Addendum #3

Project: 2024 – Fishers Elementary School Addition & Renovations

PROJECT NO: 2021119 DATE: 02/09/2024 BY: Josh Cannaday

DRAWING NUMBER A202C PROJECT NUMBER 2021119

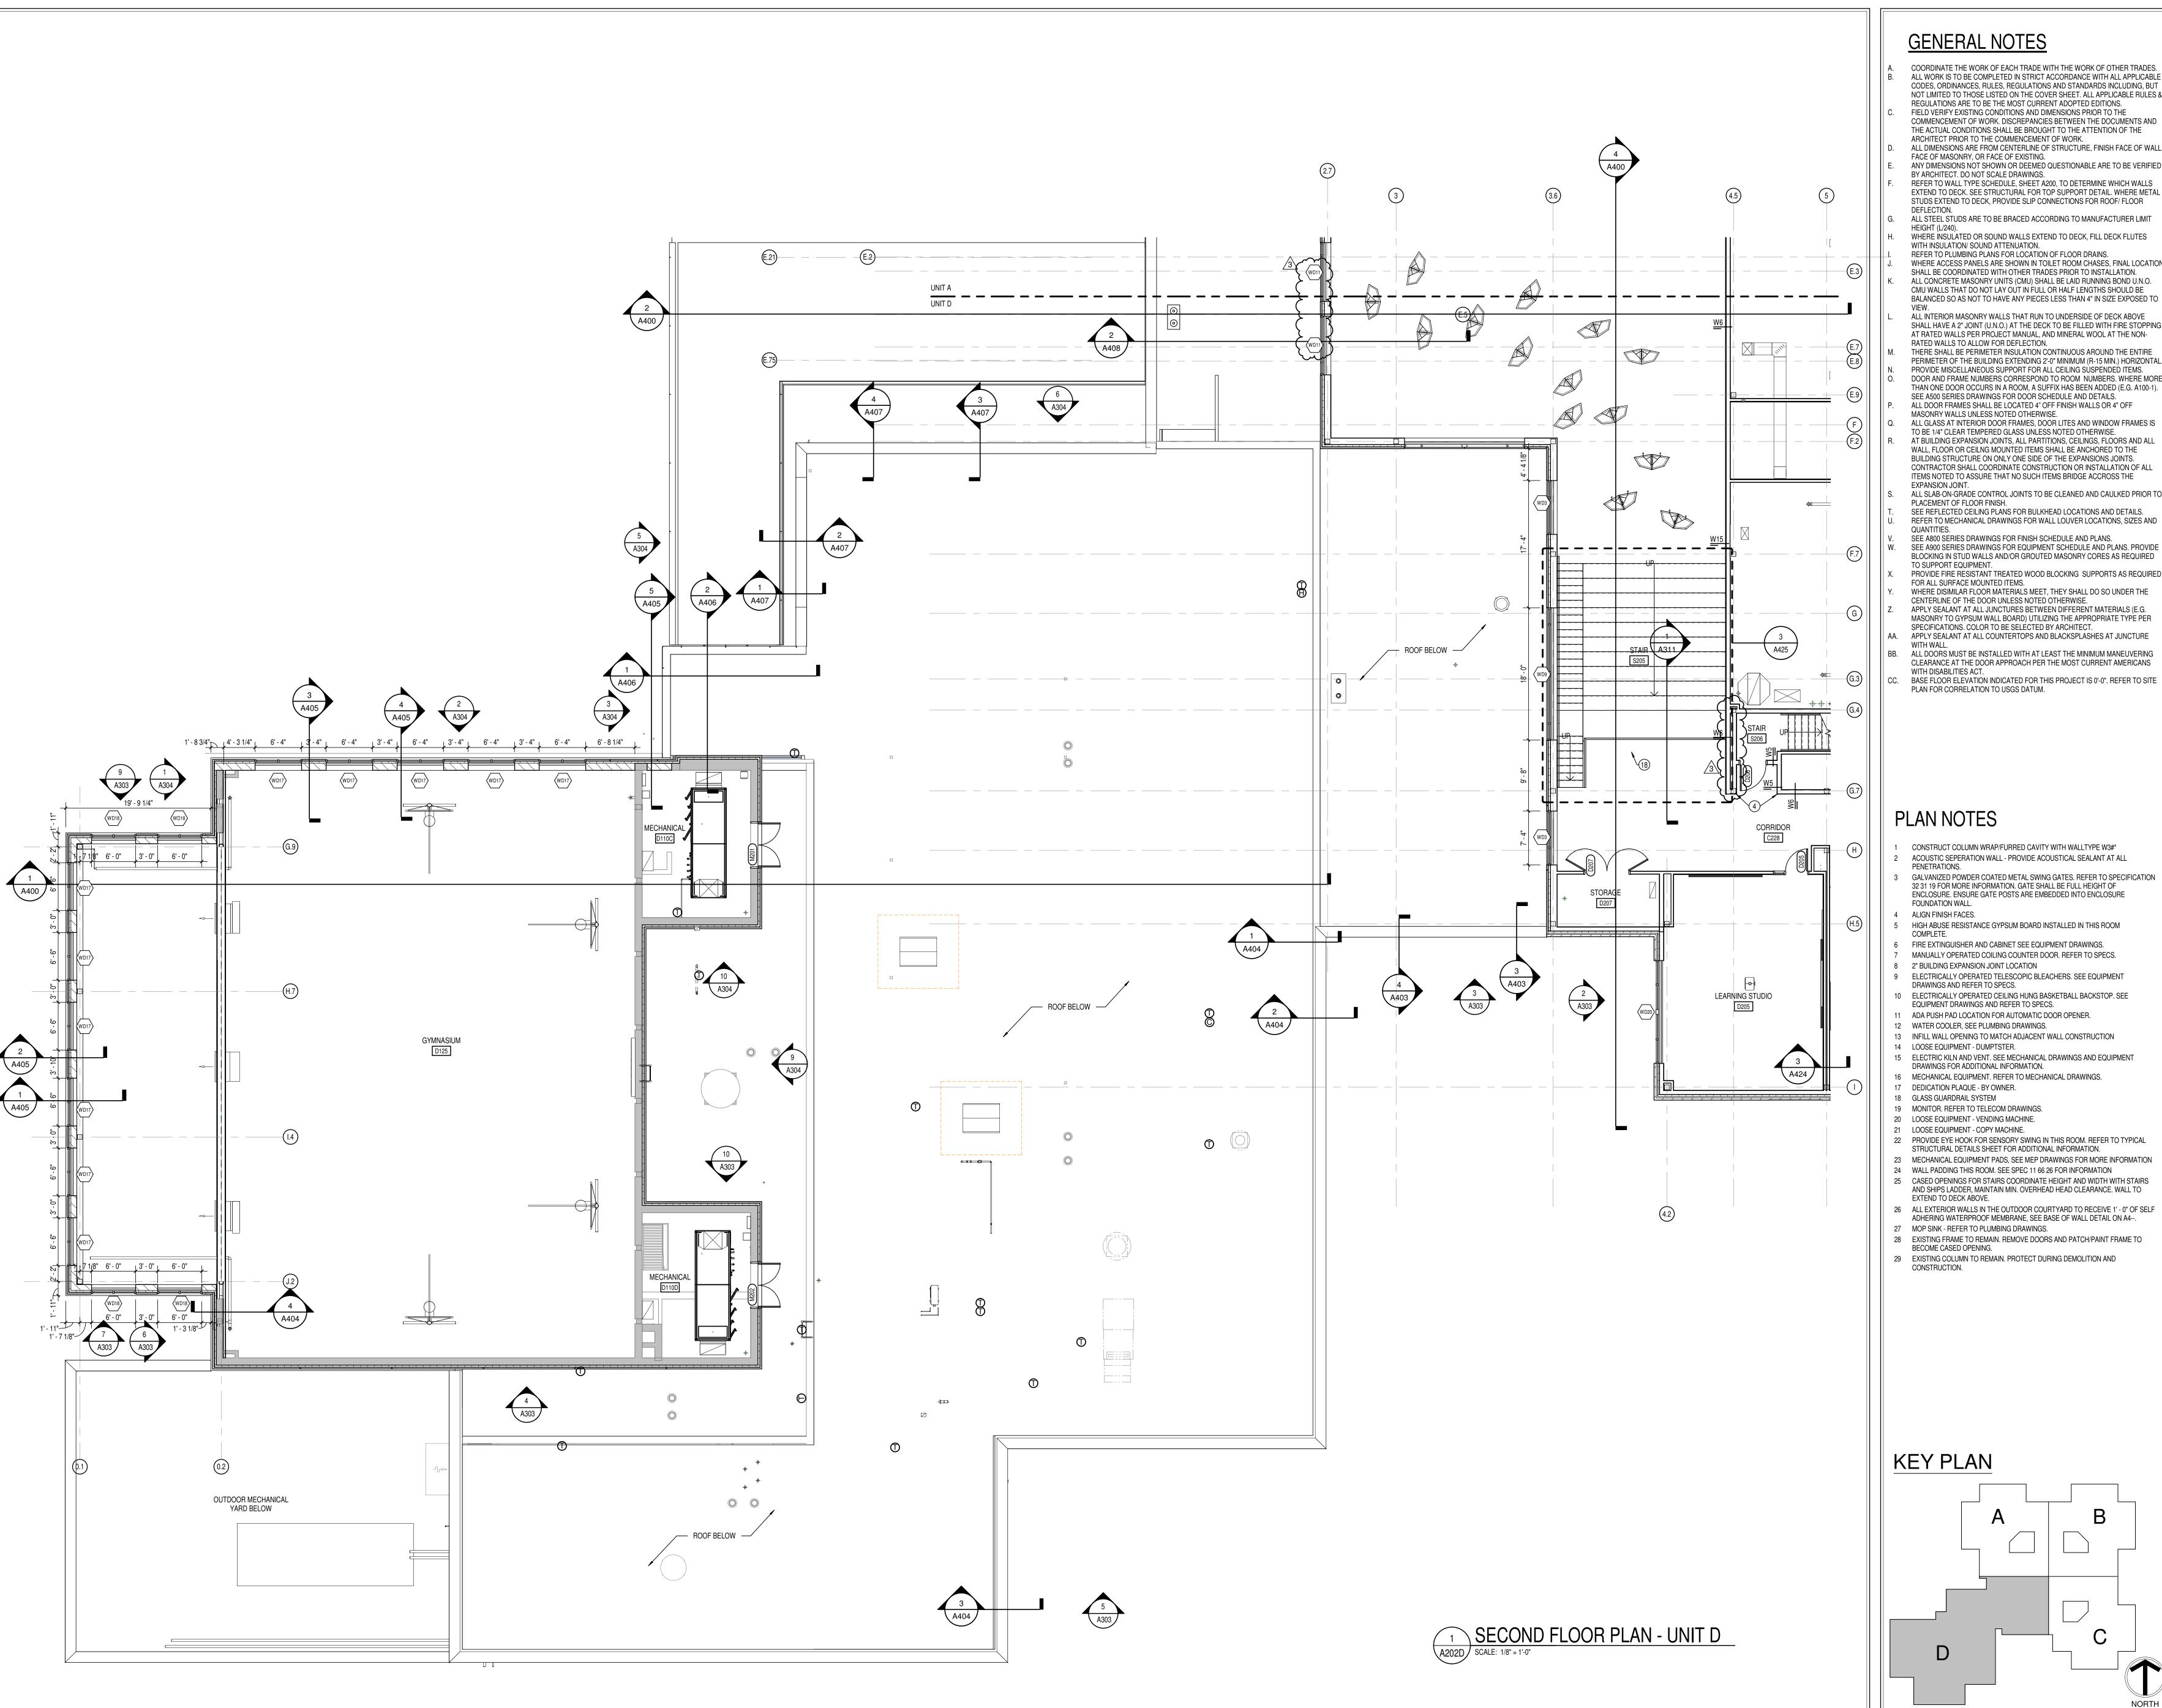
A. Add wall chase in Stair S206

DRAWING NUMBER A404

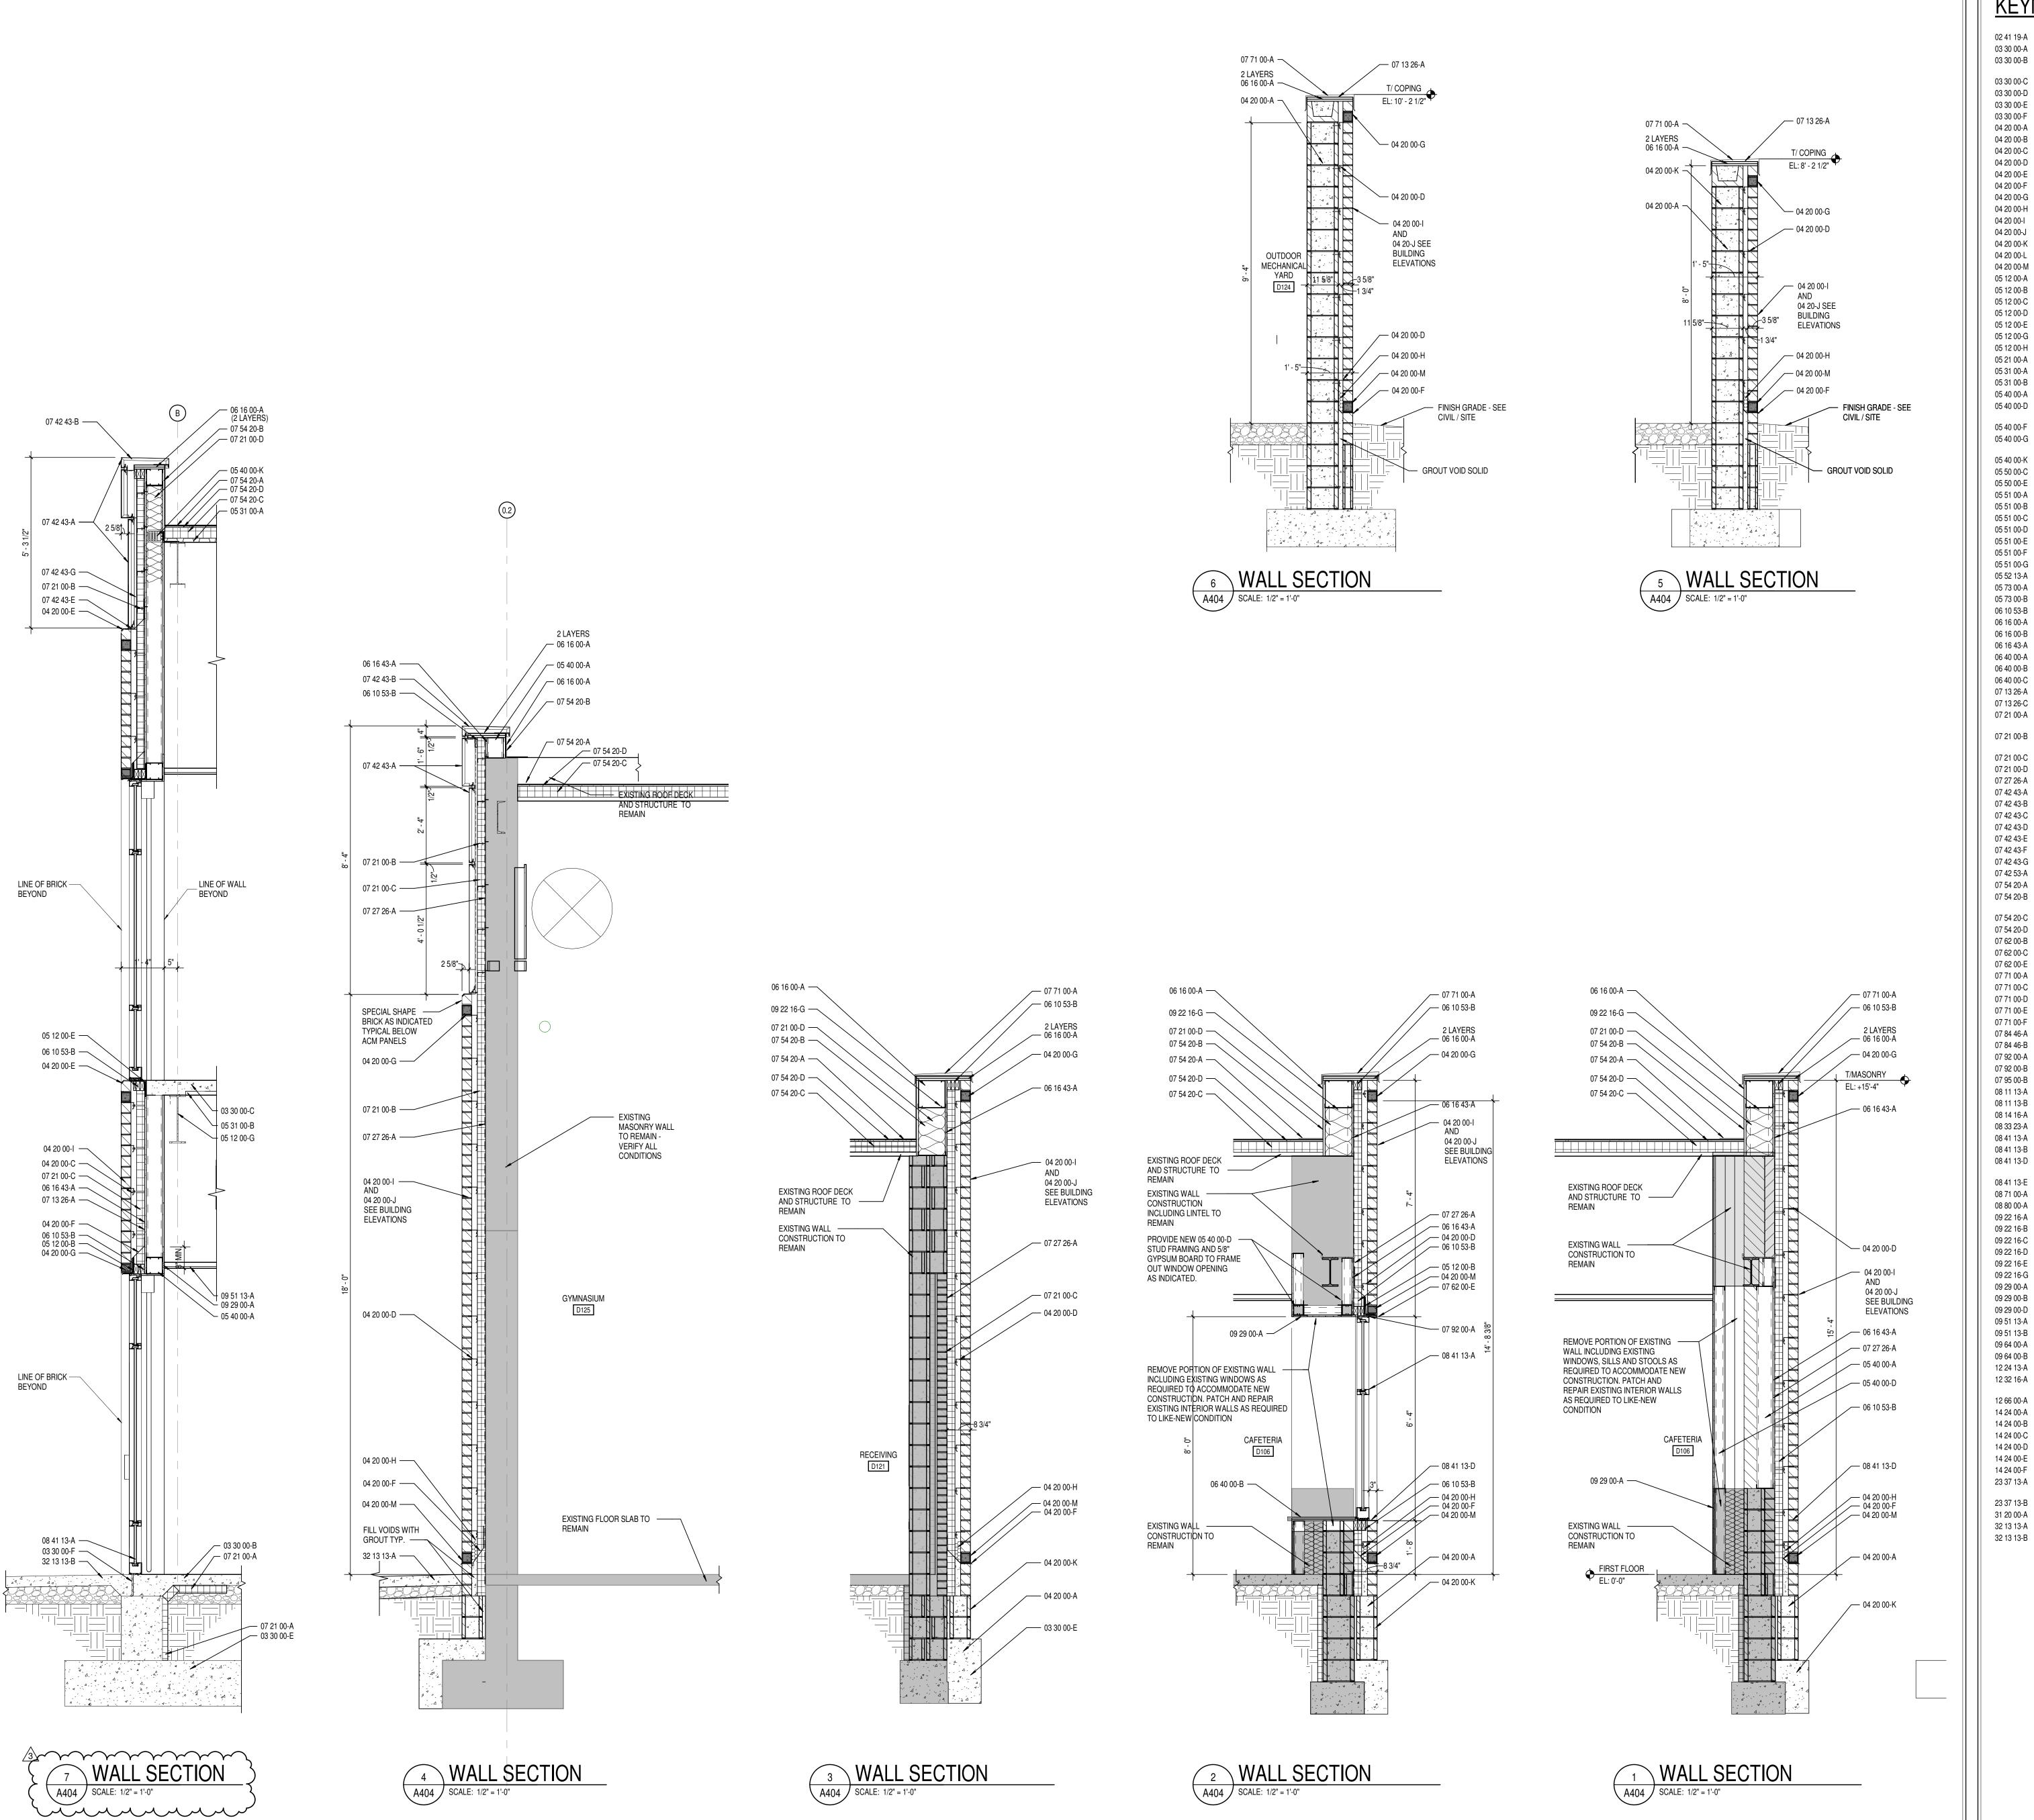
- A. Add section callout 5/A407 to 1/A400
- 4.16 A402 Wall Sections
 - A. Add section 5/A402
- 4.17 A404 Wall Sections
 - A. Add section 7/A404 to sheet
- 4.18 A406 Wall Sections

DRAWING NUMBER A501

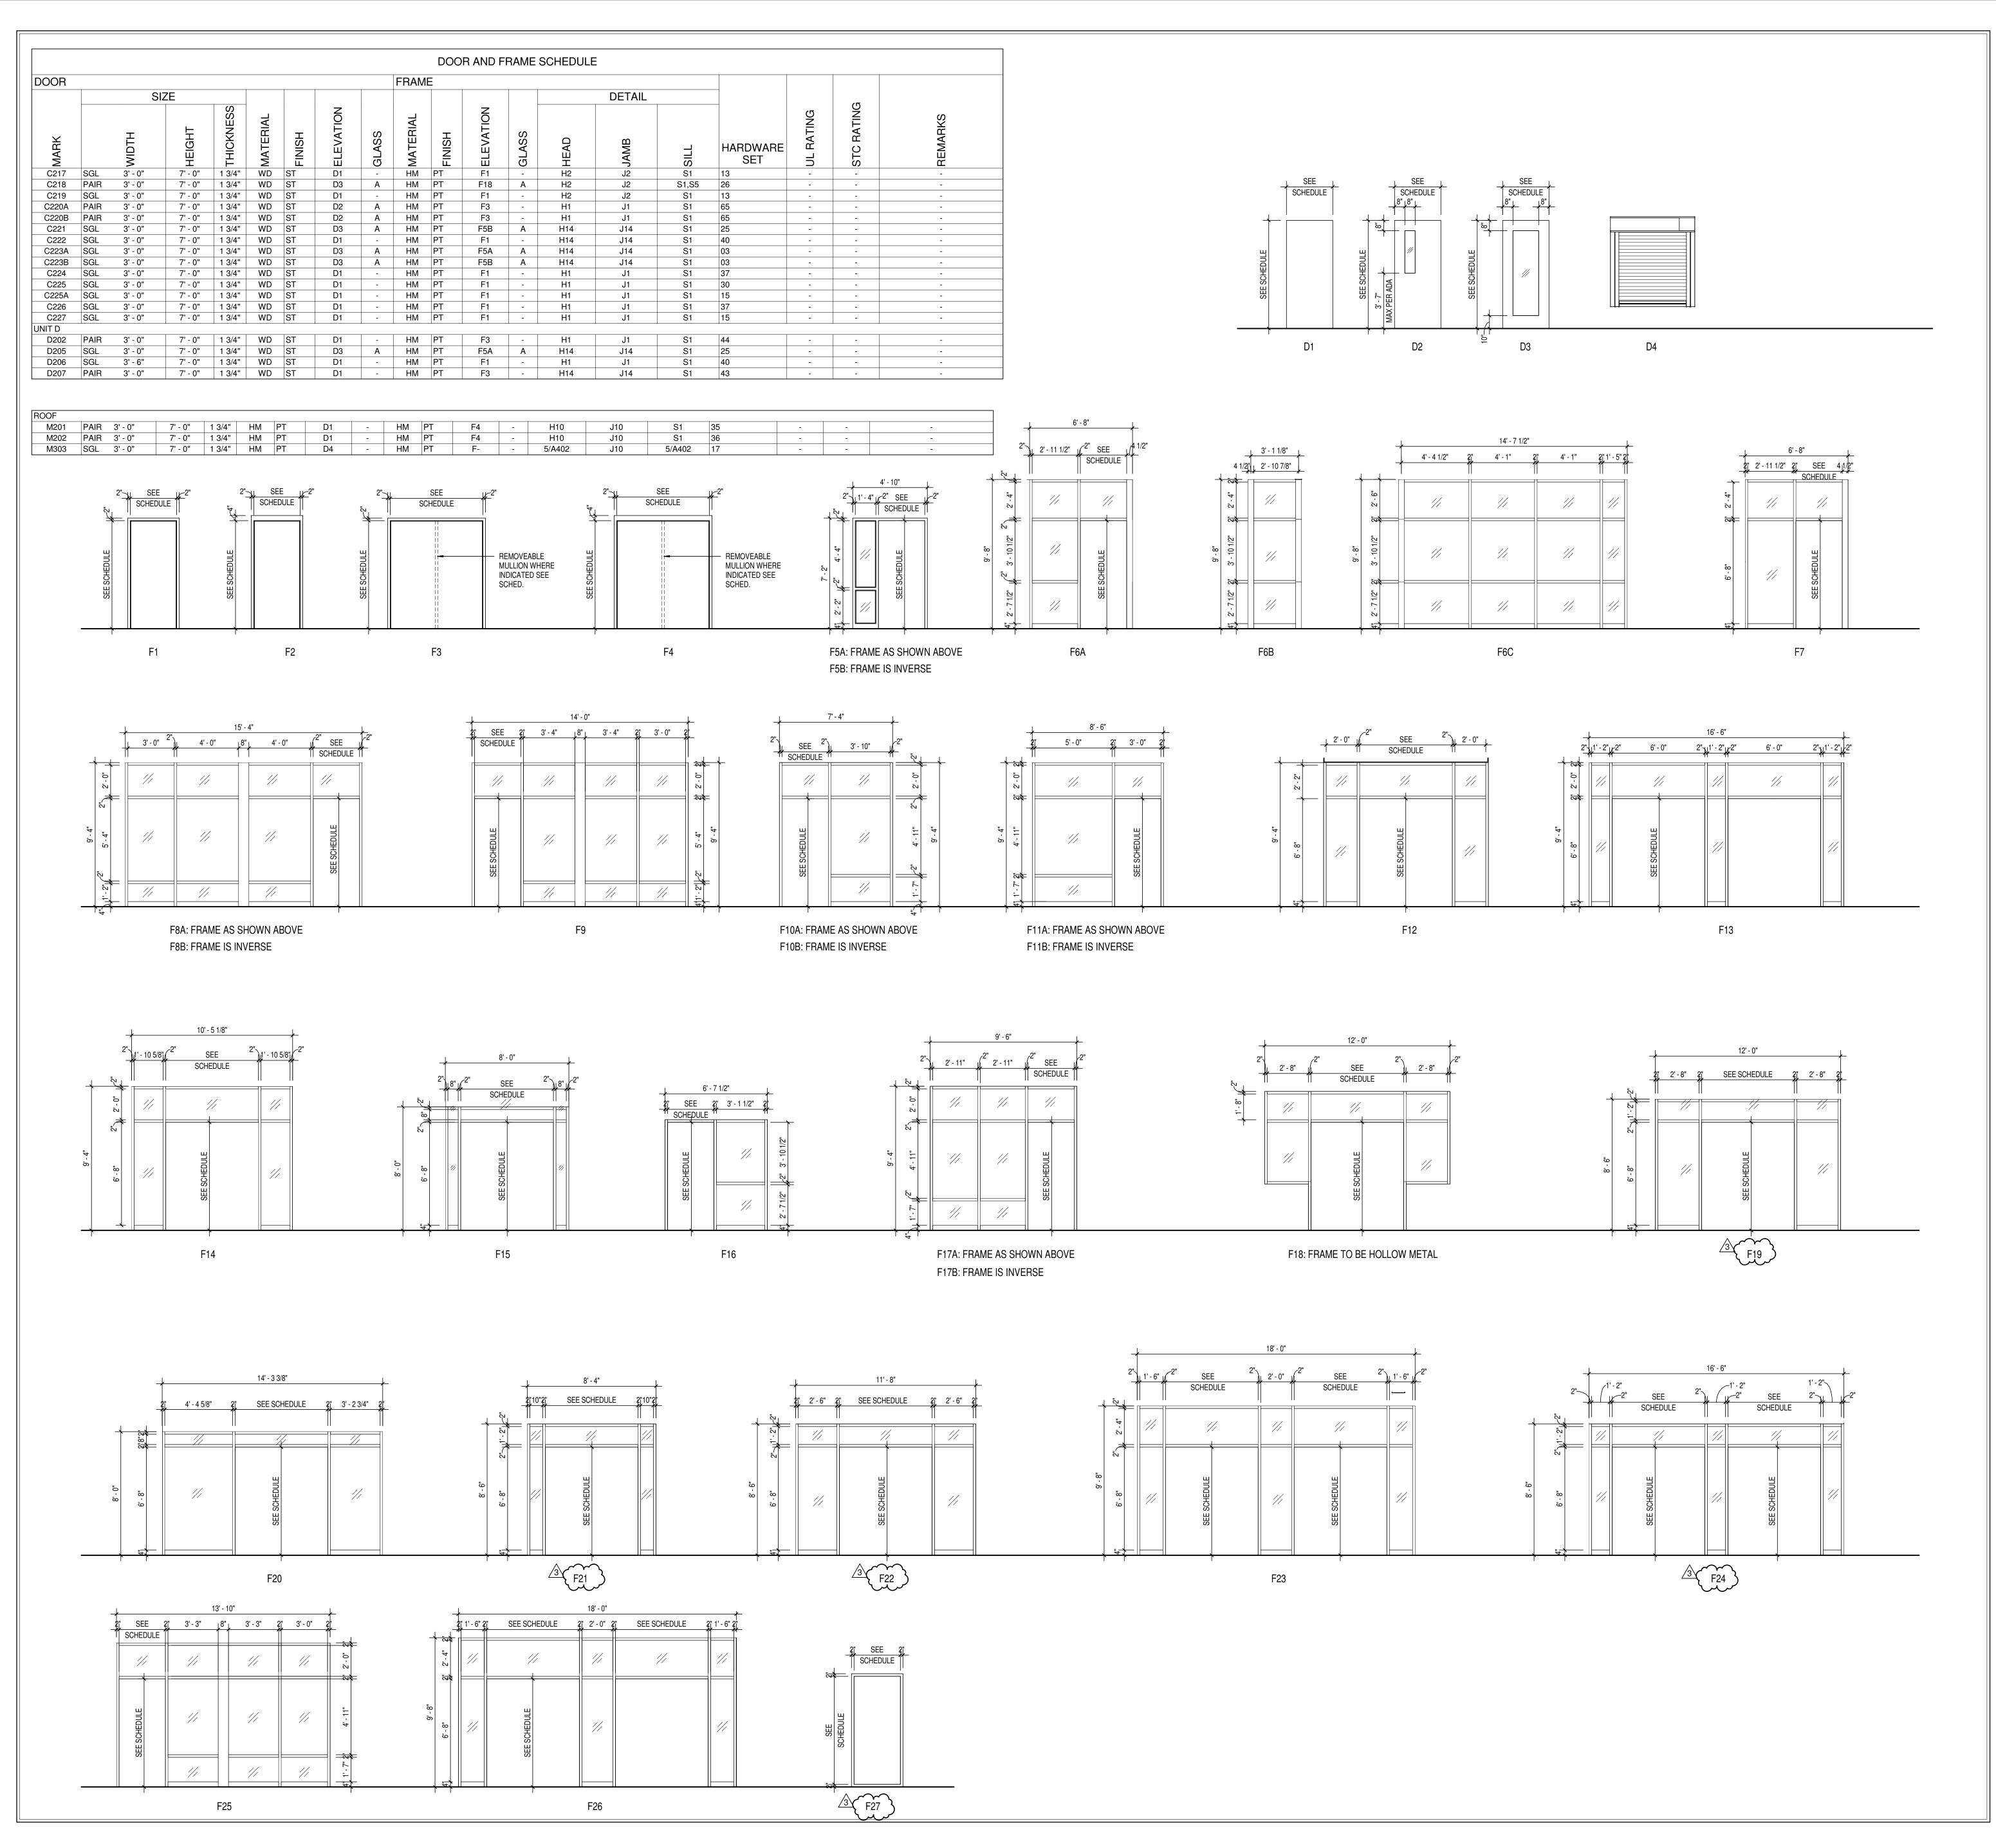
- A. Revise section 4/A409 for expansion connection between canopy and vestibule wall
- 4.21 A501 Door Schedule
 - A. Revise frame type for doors D110C and D110D to F24.

- B. Delete all instances of glazing type D from schedule.
- 4.22 A502 Door and Frame Elevations
 - A. Revise frames: F19, F21, F22, F24
- 4.23 <u>A503 Window Elevations</u>
